CITY OF ST. AUGUSTINE CORRIDOR REVIEW COMMITTEE

A G E N D A

5. (a) HP2024-0032 Nine Oaks Development, Inc. - Applicant
Broudy Bros., Ltd. - Owner
212 W. King Street

GATEWAY PARKING GARAGE & RETAIL/ OFFICE BUILDING
WEST KING STREET
ST. AUGUSTINE , FLORIDA

4 NORTH ELEVATION - OVERALL
1/16" = 1'-0"

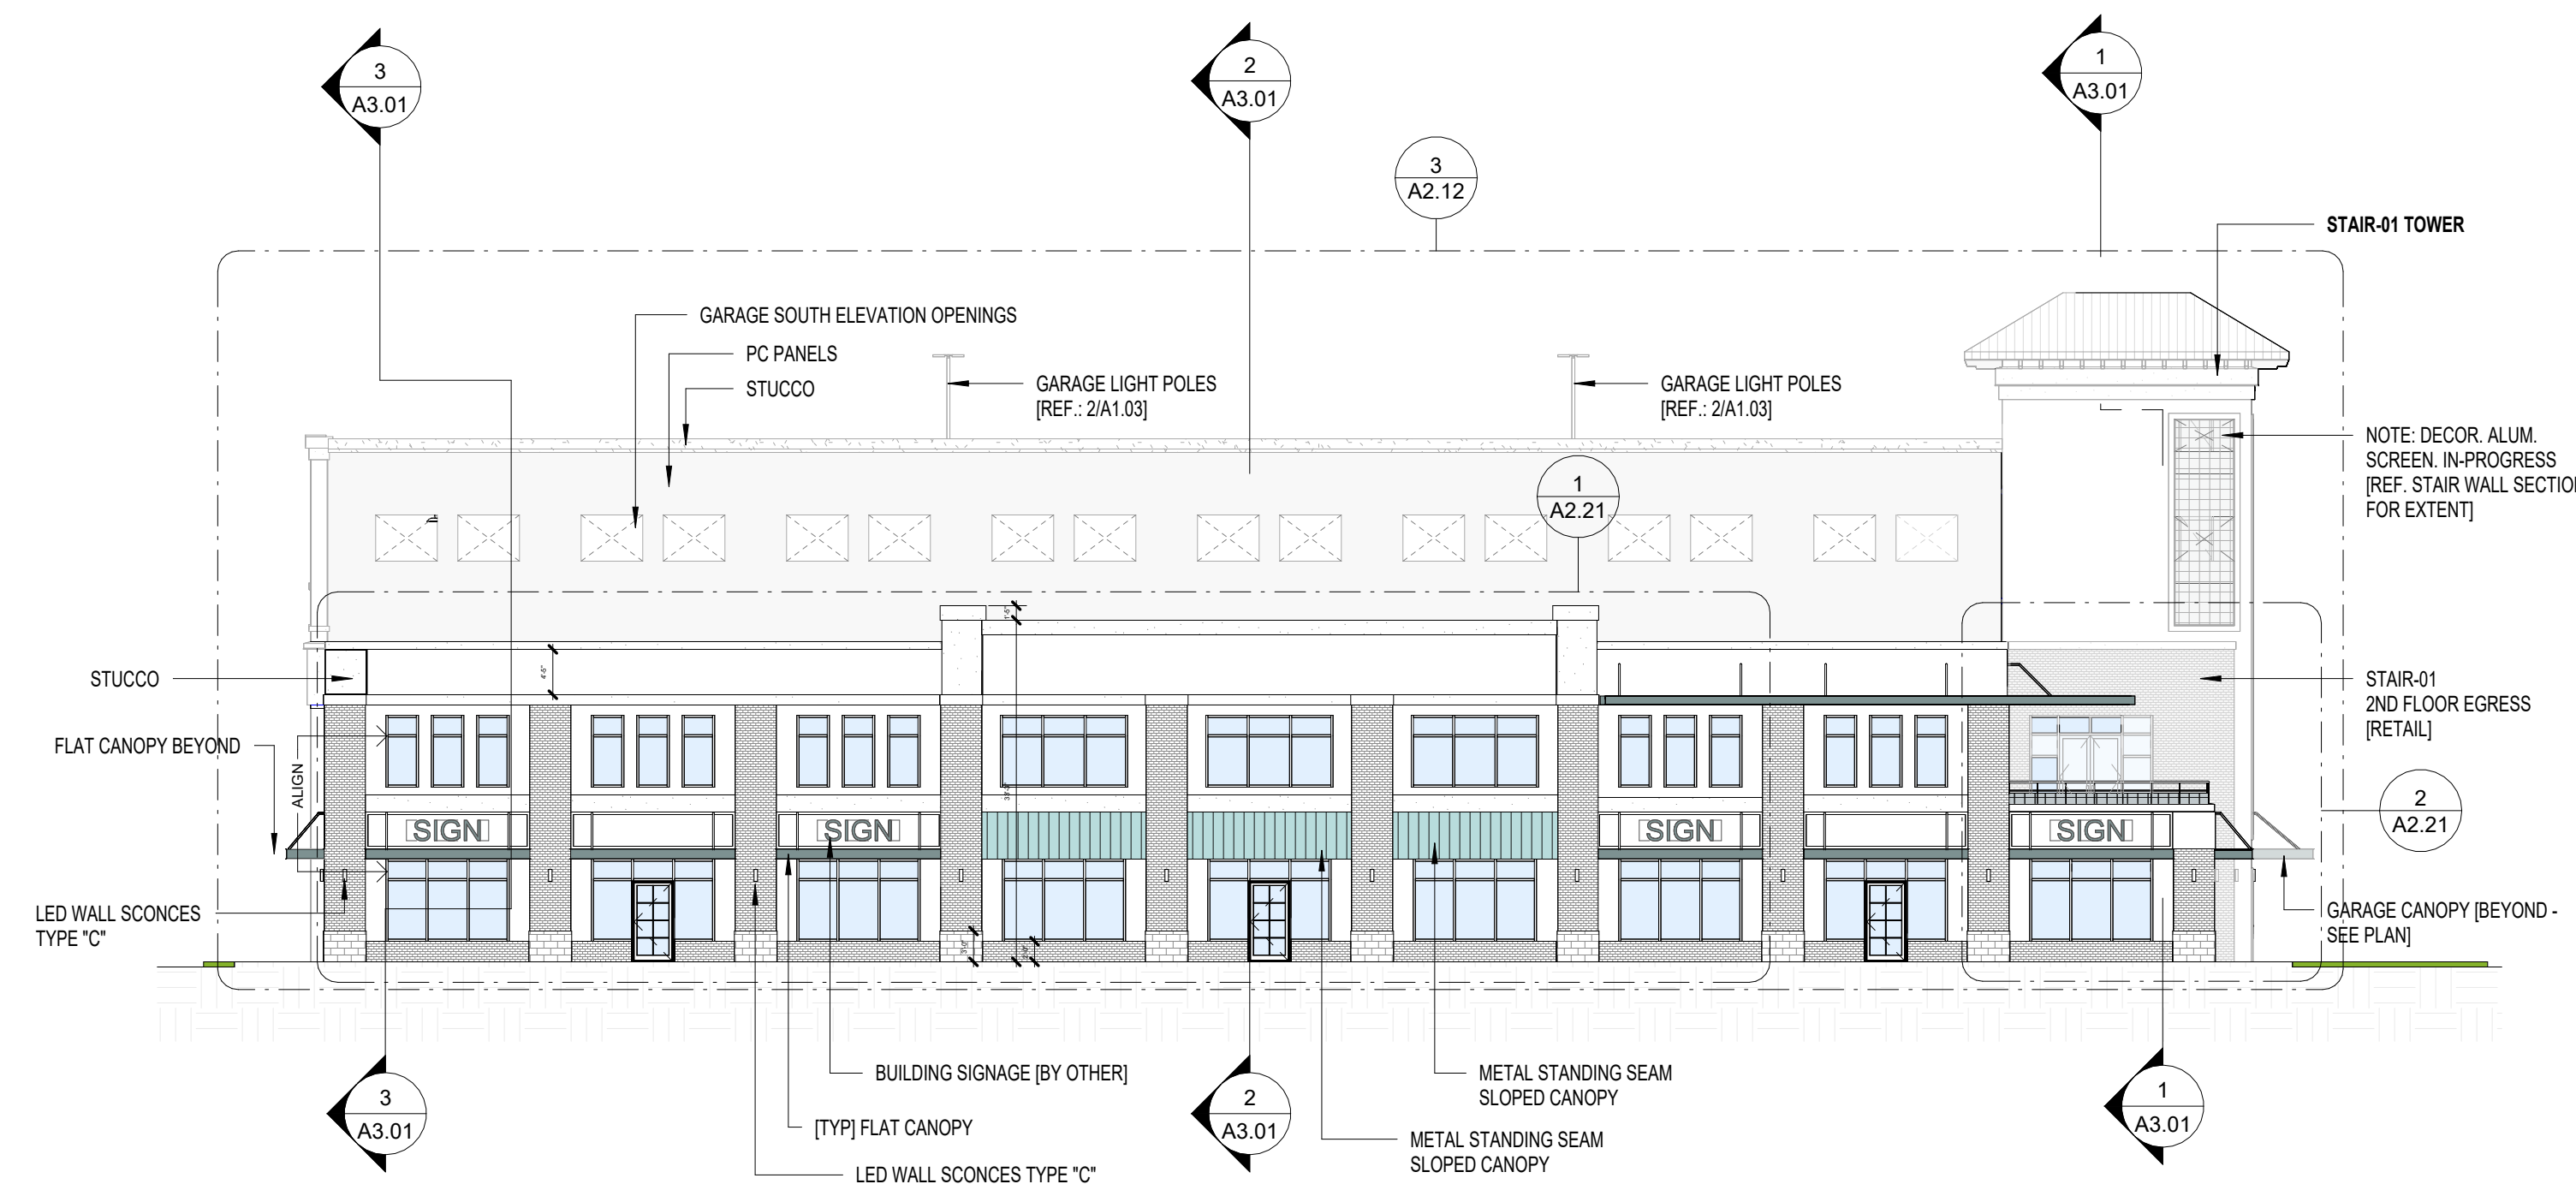
- j. Bulkheads between 12 and 30 inches above the finished floor are required per the DSEC. The proposed storefront systems and proposed elevation drawings do not feature bulkheads. **Response: The design has been revised to include 24-inch-high bulkheads. See Sheets A0.14, A2.01 and A2.21.**

A2.12

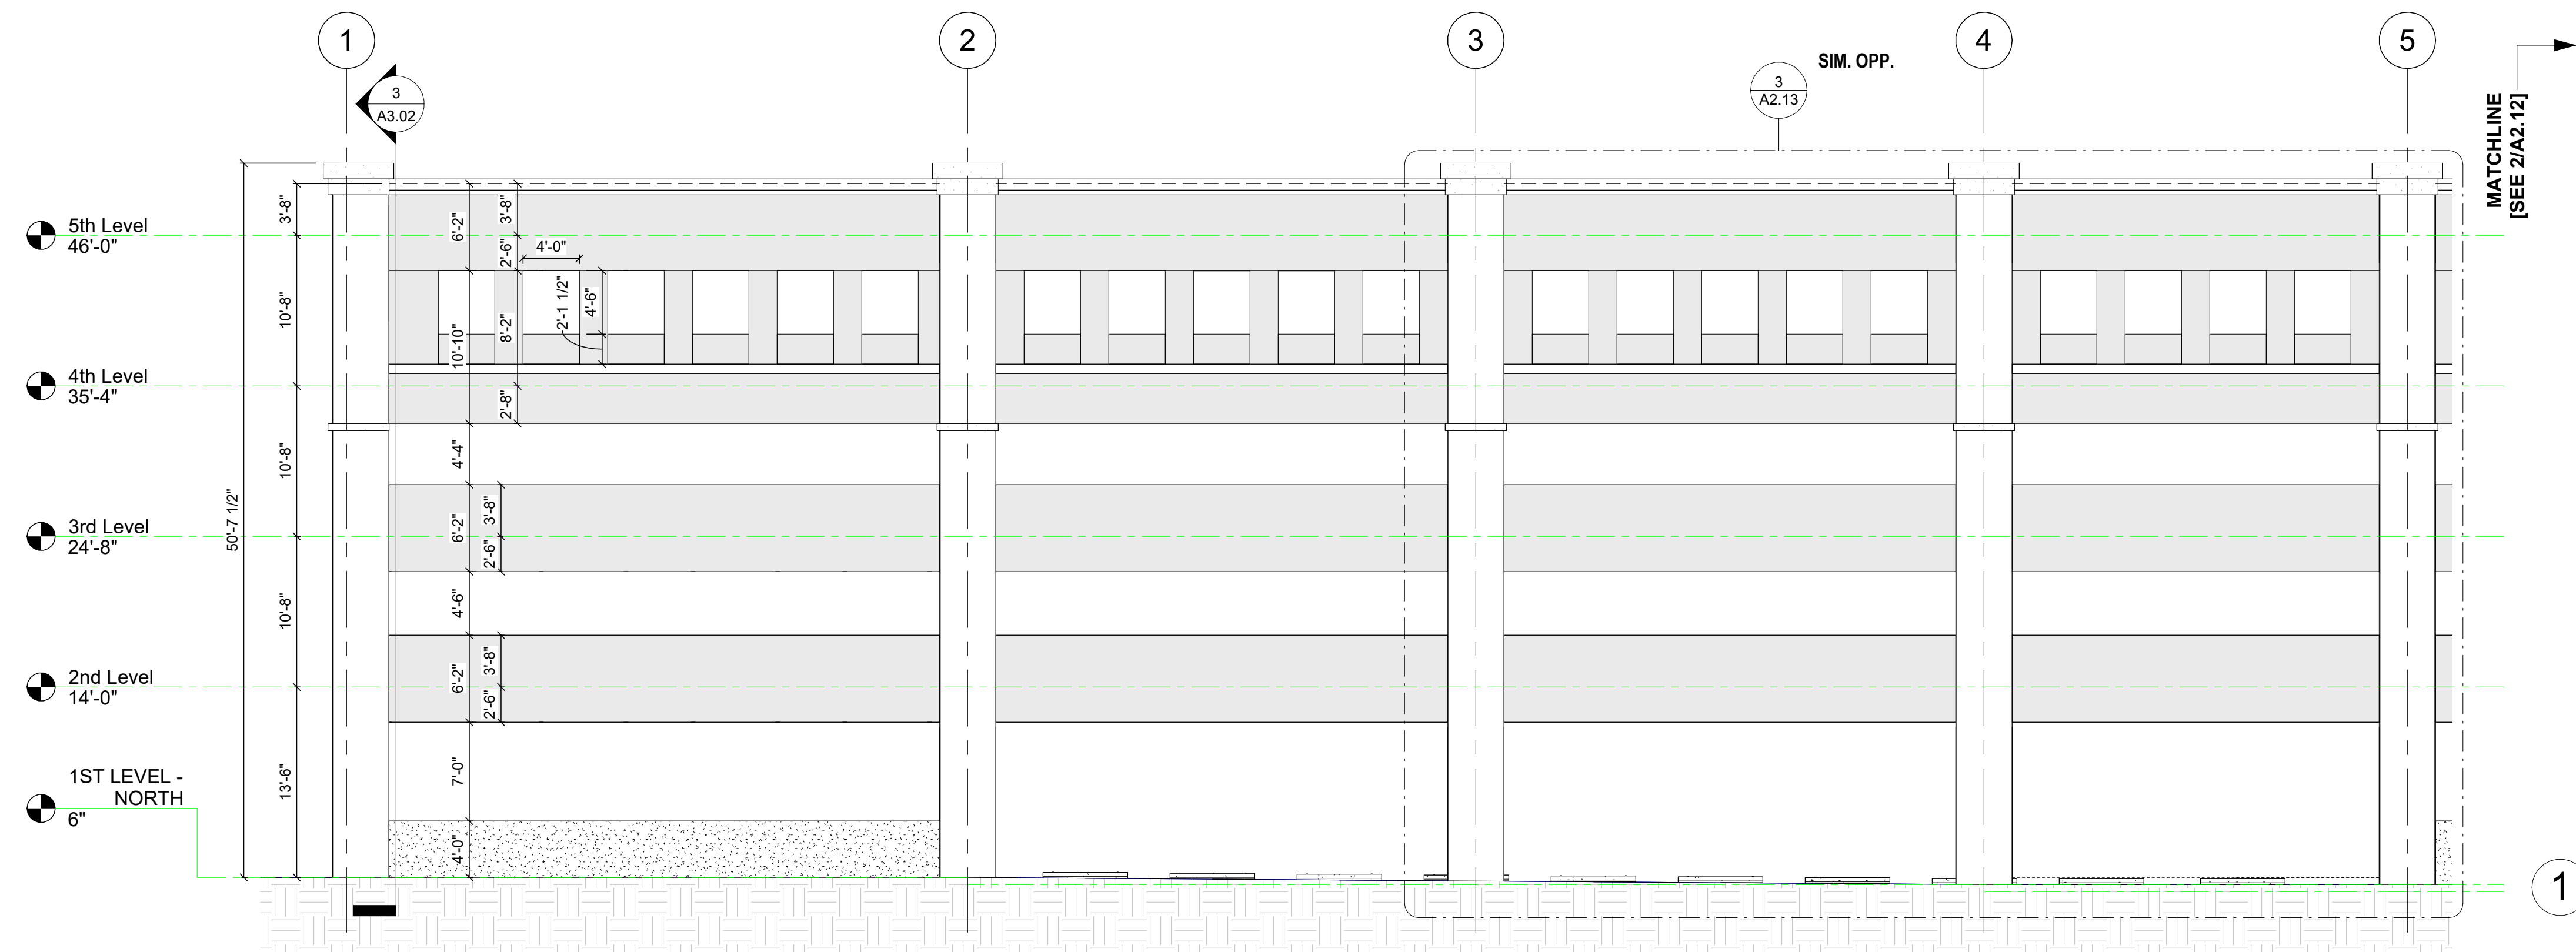
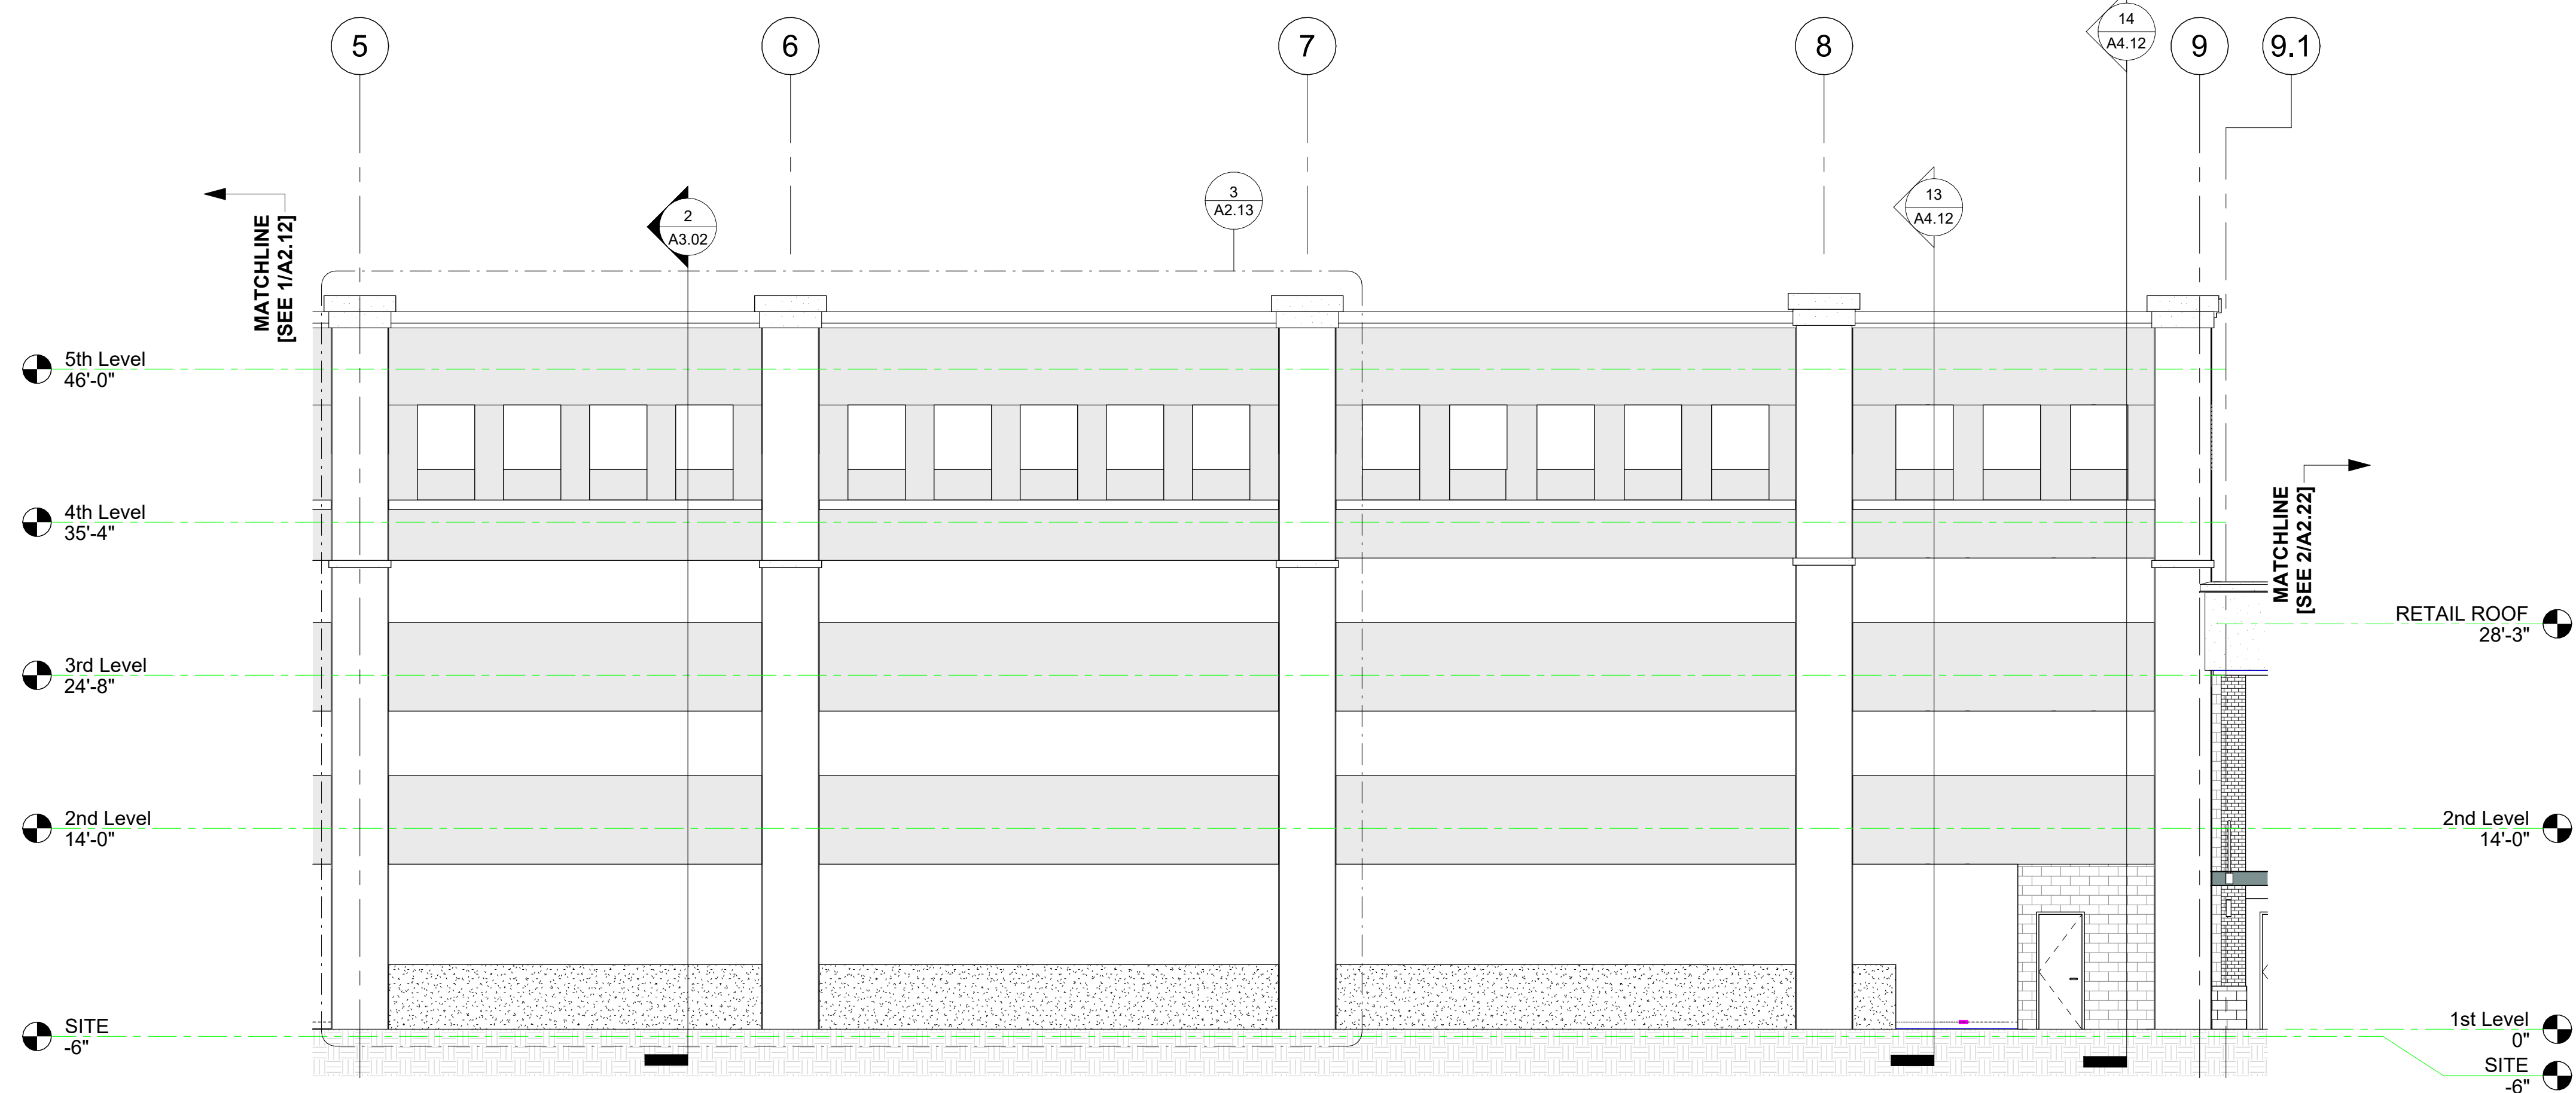
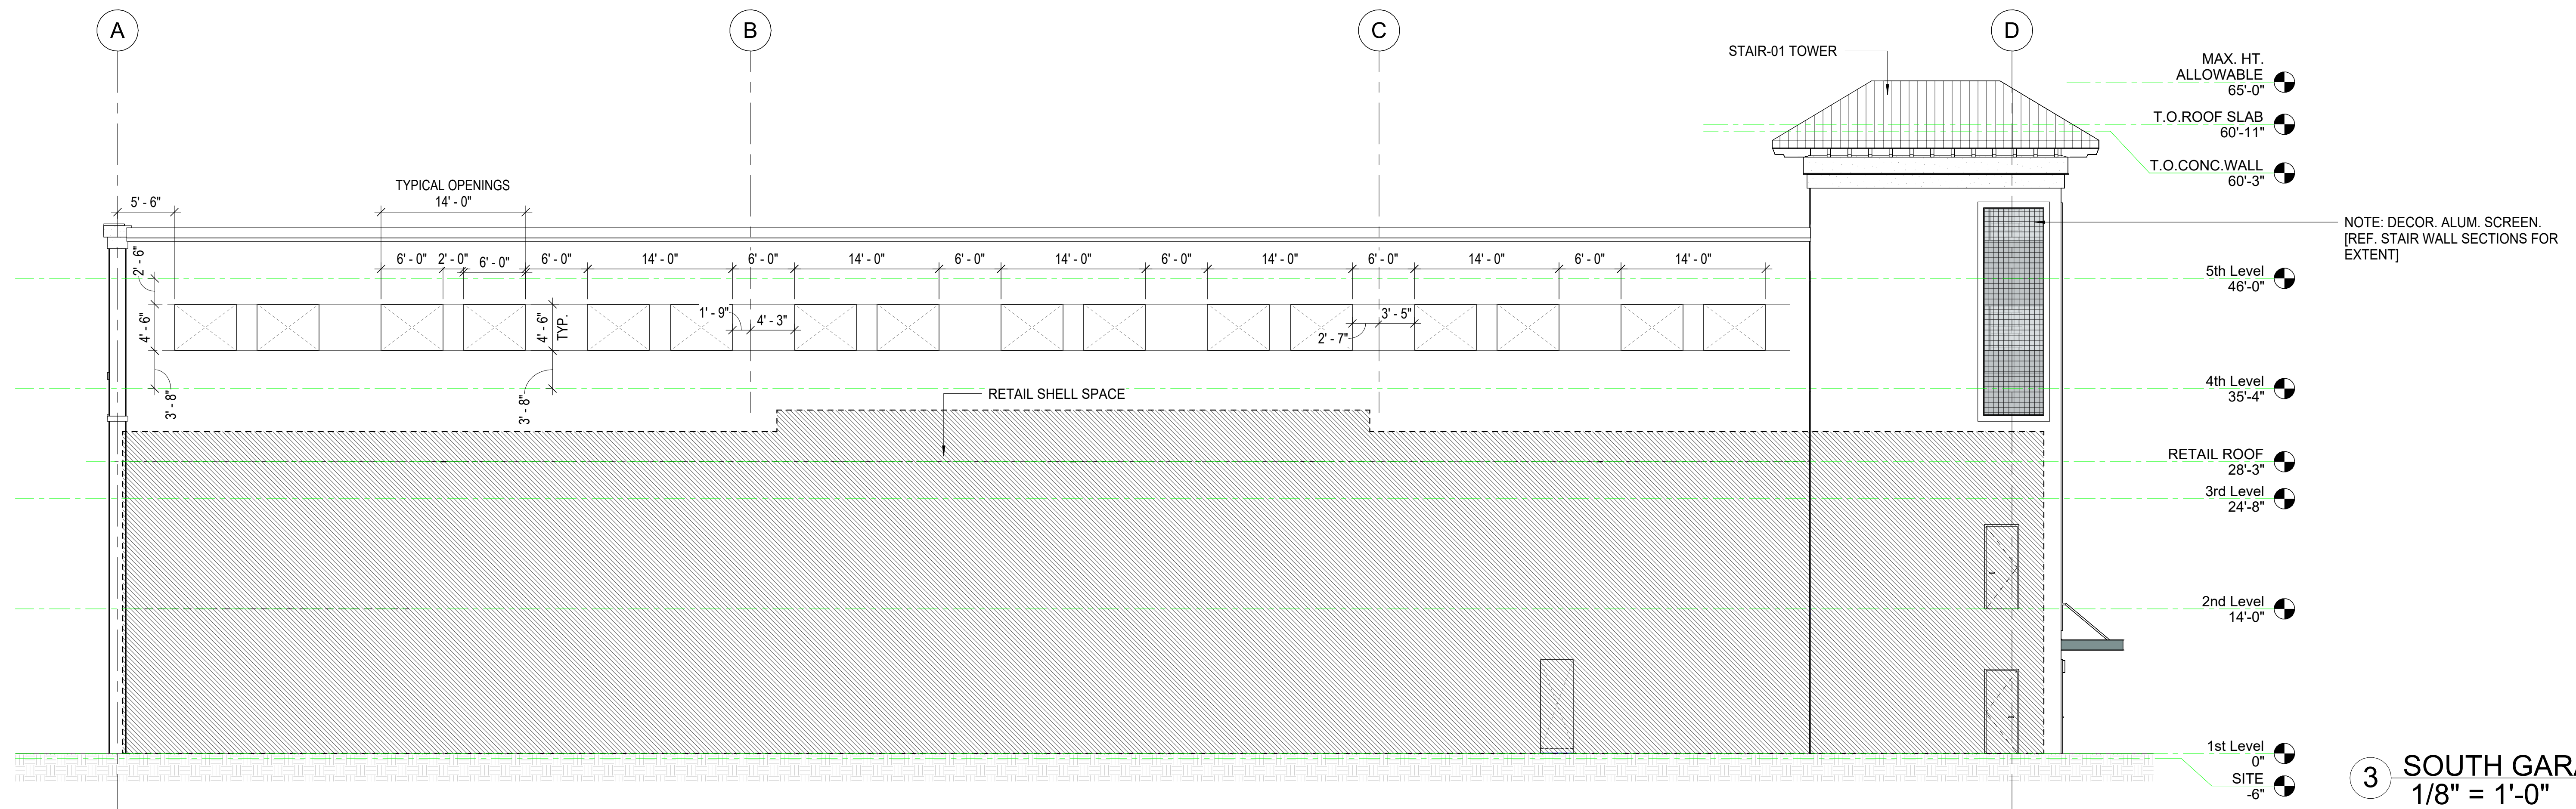
- m. The top 2 levels of the parking structure visible above the retail space must include a landscaping strip along the façade with a minimum depth of 5 feet. **Response: It was discussed during the staff review on 7/23/2024 that the wall above the 2-story retail building will be barely visible from across West King Street. Also, new openings were added at the top of the garage south wall. See revised Sheets A2.01. A2.12 and revised renderings.**
